A 23147

*on 10,000 ft.*  
SEWAGE DISPOSAL TESTING  
STATE OF MARYLAND - DEPARTMENT OF HEALTH AND MENTAL HYGIENE

HOWARD COUNTY HEALTH DEPARTMENT  
ENVIRONMENTAL HEALTH SERVICES  
P. O. BOX 476, ELLICOTT CITY, MARYLAND 21043  
TELEPHONE: 465-5000, EXT. 356

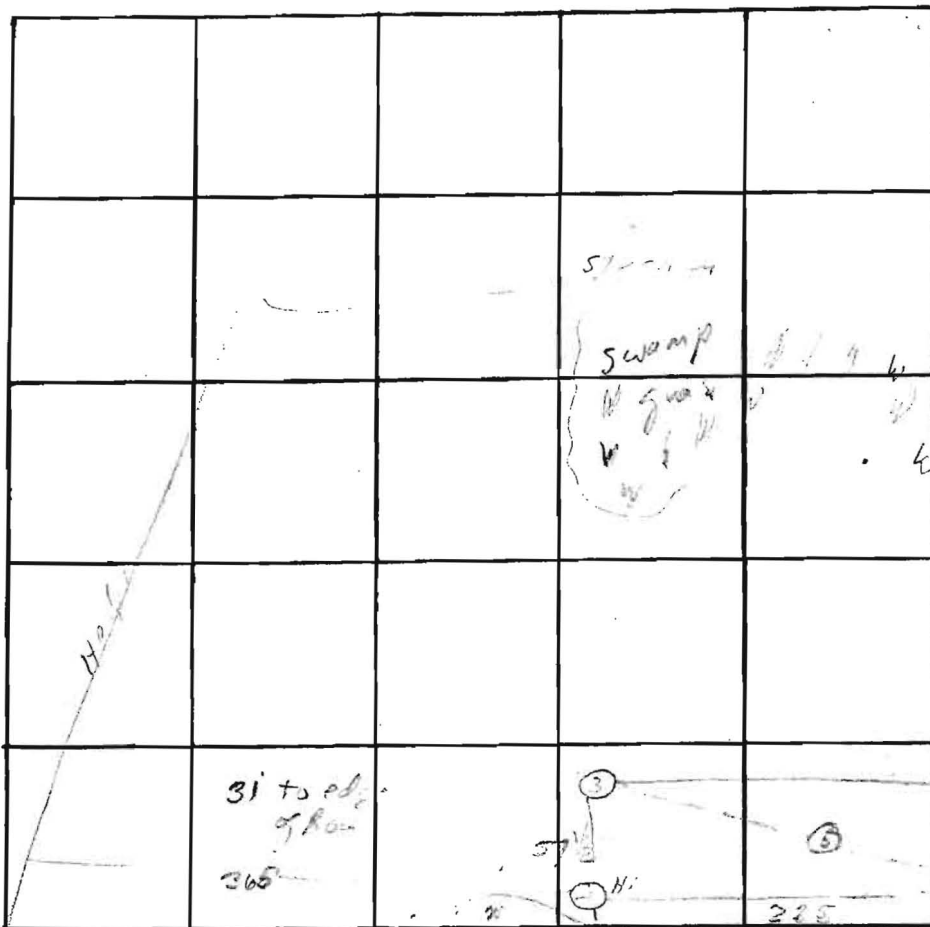
*Dry well as shown on plan 1 in 3' max depth 10'  
12x12, Trench 1 in 3' max depth 8' 95' long, to run  
parallel to Nichols Drive 10' from lot line*

REASONS FOR REJECTION OR HOLDING *checked Elevation with Dennis From Boons  
house site too low for use of system*
